TECHNICAL BULLETIN

JTB00242
16 NOV 2011

Front Bumper Beam Pedestrian Impact Sensor Rework

The New XK (X150)

E137906

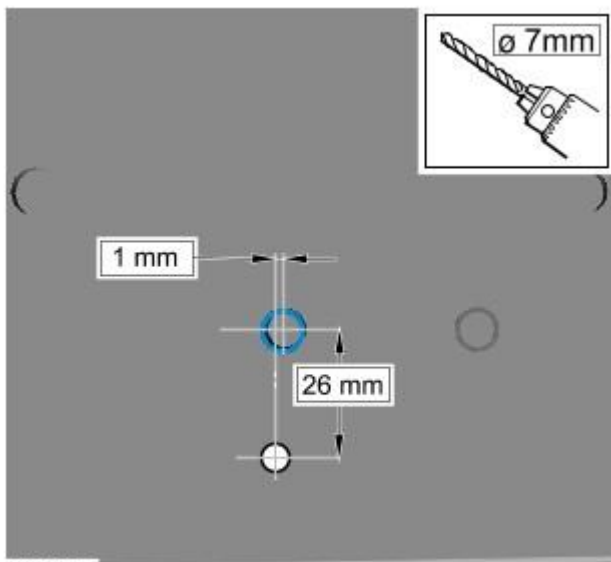
1. Disconnect the battery ground cable (see Topix section 414-01).
2. Remove the front bumper (see Topix section 501-19).
3. Remove the pedestrian impact sensor.
 1. Remove the 2 bolts.
 2. Discard one of the bolts.

E137907

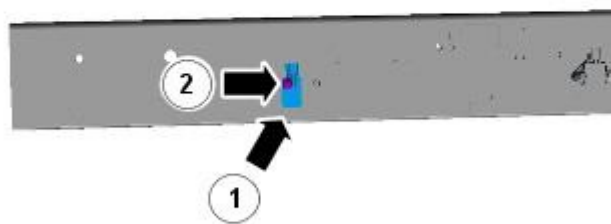
5.  **CAUTION: Make sure that the sensor dowel is correctly located in the hole.**

Install the new sensor.

1. Install the dowel on the new sensor to the new hole.

2. Install the bolt and tighten to 10 Nm.
